Mk II Inlet port section pre 219016

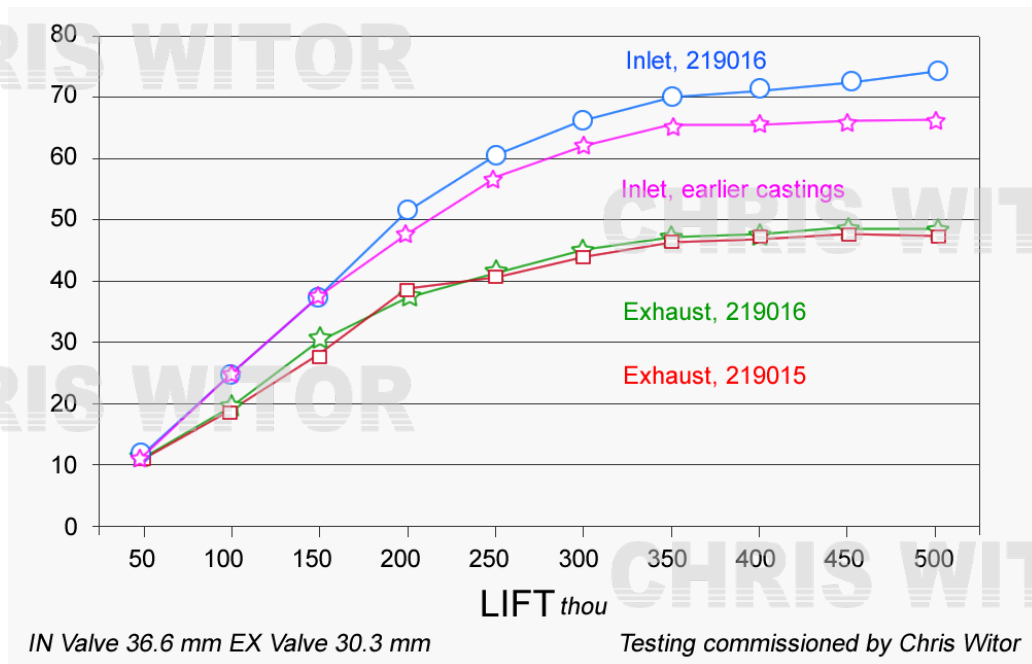
Pre 219016 lack material here, turning flow into the valve rather than into the combustion chamber resulting in a 10 cfm loss of flow at .500" valve lift
